# Access Compliance Report

### (Curb Ramps)

| Intersection ID: 19453                  | Main Street: ALDERSHOT_CT | Cross Street: KINGSGATE_PL              | Location: SE           |
| ADA ID: D44ADD1F8BFE                    | Ramp Type: PerpDiag       | Initial Pass/Fail: Fail                 | Overall Compliance: No |

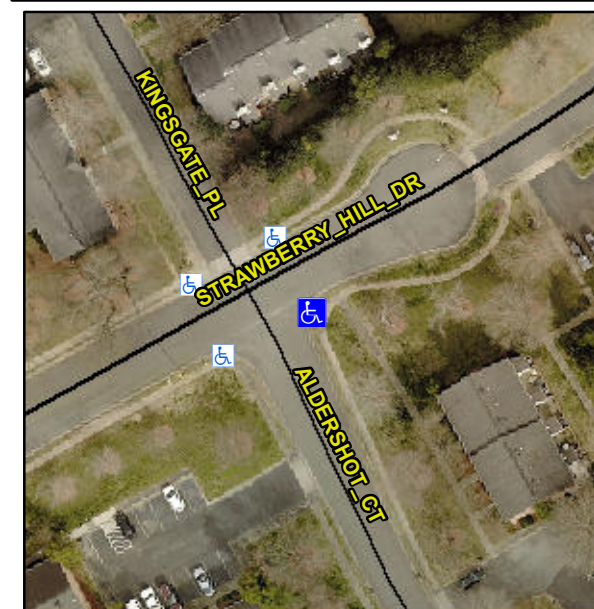
**R304.2.2, R304.5.3**

| Compliance | Description           | Data  | Compliance | Description                 | Data  |
|------------|-----------------------|-------|------------|-----------------------------|-------|
| N/A        | Ramp Length (in)      | 63.0  | No         | Ramp Slope (%)              | 8.5   |
| Yes        | Ramp Width (in)       | 48.0  | No         | Ramp XSlope (%)             | 4.3   |

**Remove & Replace Curb Ramp With Two New Directional Ramps or Equivalent.**
